UNITED STATES PATENT AND TRADEMARK OFFICE

APPLICATION NO.	FILING DATE	FIRST NAMED INVENTOR	ATTORNEY DOCKET NO.	CONFIRMATION NO.
09/529,374	04/12/2000	HANS-BERTH KLERSY	3933.002	6961

Office Action Summary

DETAILED ACTION

FIG. 1

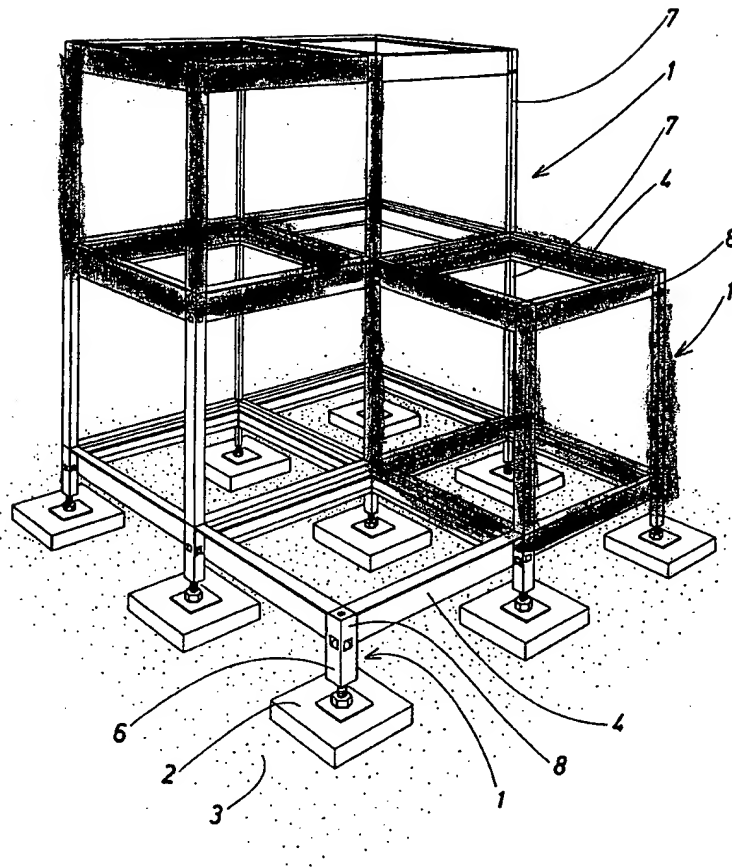
In response to the applicant's argument that ANDERSON does not disclose the use of a finished modular 3-D frame, as defined earlier, a module is a series of standardized units for use together as a unit of architecture or furniture. The modules of ANDERSON are colored in red, see the marked attachment. ANDERSON also discloses that the building includes exterior walls,

windows and doors, column 7, line 57-64. Further, the structure of ANDERSON is a modular unit in that the series of elements (i.e. the floor/ceiling (4), pillar sections (6,7), transverse bearer (21,25), pins (18,20), gussets (36) and exterior finishings are all assembled to form a module, as previously indicated in red, see the marked attachment.
